Access Compliance Report

Public Rights-of-Way

(Curb Ramps)

Intersection ID: 13891	Main Street: CLEMENT_AV	Cross Street: E_7TH_ST	Location:	N
ADA ID: 3938B6C87D7E	Ramp Type: Perp	Initial Pass/Fail: Fail	Overall Compliance: No	Severity Score: 1.25
Codes/Mitigation Info/Possible Solution		Field Measurements/Component Compliance

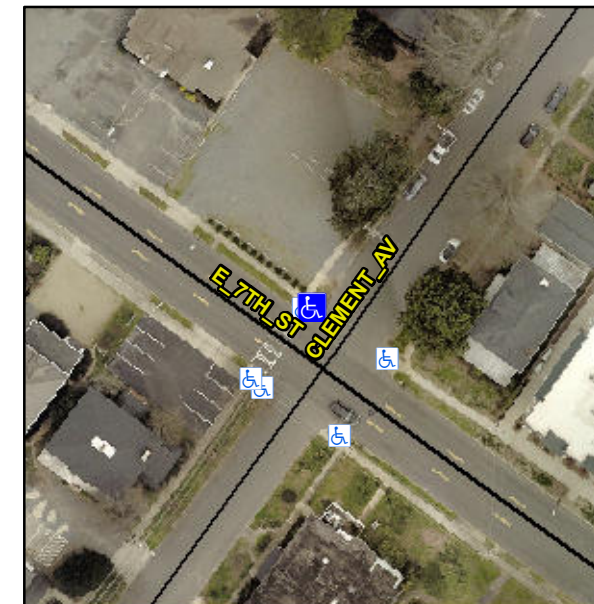
R304.5.3

Compliance	Description	Data	Compliance	Description	Data
N/A	Ramp Length (in)	61.0	Yes	Ramp Slope (%)	6.3
Yes	Ramp Width (in)	49.0	No	Ramp XSlope (%)	3.8
N/A	Flare Type LT	N/A	N/A	Flare Type RT	N/A
N/A	Flare Slope LT (%)	N/A	N/A	Flare Slope RT (%)	N/A
N/A	Flare Traversable LT?	N/A	N/A	Flare Traversable RT?	N/A
N/A	Landing Length (in)	N/A	N/A	DWS Provided?	N/A
N/A	Landing Width (in)	N/A	N/A	DWS Contrast?	N/A
N/A	Landing Slope (%)	N/A	N/A	DWS Length (in)	N/A
N/A	Landing X Slope (%)	N/A	N/A	DWS Full Width?	N/A
N/A	Landing Curb? (Y/N)	N/A	N/A	DWS Offset (in)	N/A
N/A	Shared Landing?	N/A			
N/A	Gutter Ponding?	N/A	N/A	Gutter Slope (%)	N/A
N/A	Gutter Lip Ht (in)	N/A	N/A	Gutter X Slope (%)	N/A
N/A	Painted X Walk1?	No	N/A	Painted X Walk2?	N/A
	X Walk 1 Direction	To SE		X Walk 2 Direction	N/A
N/A	X Walk 1 Width (in)	N/A	N/A	X Walk 2 Width (in)	N/A
	X Walk 1 Slope (%)	6.3		X Walk 2 Slope (%)	N/A
	X Walk 1 X Slope (%)	1.7		X Walk 2 X Slope (%)	N/A

Remove & Replace Entire Ramp.
